SERVICE ADVISORY # 06-074Suburban Furnace Intake**Models Included:**

2007 Cougar Fifth Wheels models 289 and 2811

Keystone is conducting a voluntary RECALL notification campaign in accordance with the National Highway Transportation and Safety Act. The above 2007 Keystone RV Fifth Wheels may have been manufactured with the furnace air intake tube not installed correctly. The following procedure describes how to inspect the intake and correct if necessary.

Figure 1

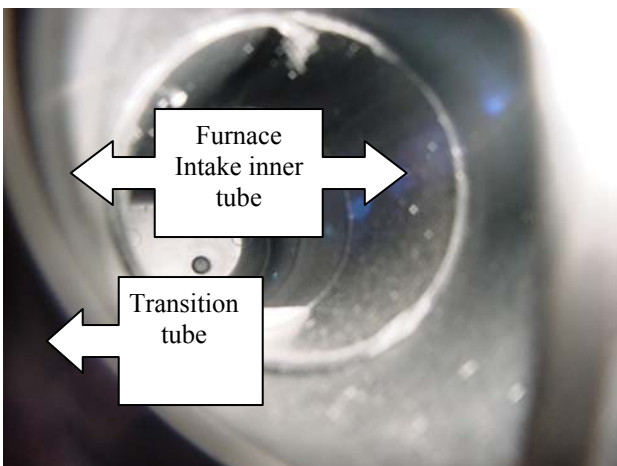
- Step 1 From the exterior of the unit locate the furnace vent cover. With a flashlight look into the upper hole and inspect to see if the transition tube (tube that joins the exterior vent cover to the intake tube on the furnace) has been installed to slide over the intake tube. See Figure 1. If these tubes are end to end or butt together, it is the incorrect installation, proceed to **TWO**.

- Step 2 If the transition tube is over the intake tube; use a tape measure to check the distance from the furnace intake to the end of transition tube as shown below. See Figure 2. Slide the tape measure into the bottom of the upper hole until it hits the end of the intake tube on the furnace. If the measurement is between 2-1/4" to 2-1/2", the installation is correct, proceed to **THREE: WARRANTY REIMBURSEMENT**. If the dimension is larger than 2-1/2", the installation is incorrect, proceed to **TWO**.

- Step 1 Remove vent cover by removing the 6 screws.
- Step 2 If transition tube is not installed over intake, reposition making sure there is a minimum of ½" overlap between the transition tube and intake tube. To verify the ½" minimum overlap, remove the 3 ½" transition tube, measure from the end of the intake tube on the furnace to the outside of the sidewall. If the measurement is more than 3", proceed to Step 3. If the measurement is 3" or less, proceed to step 5.
- Step 3 Place order for KRV# 111947 5" furnace extension tube.
- Step 4 Install 5" replacement tube by sliding it over furnace intake.
- Step 5 Replace vent cover using putty tape (if required) and sealant.
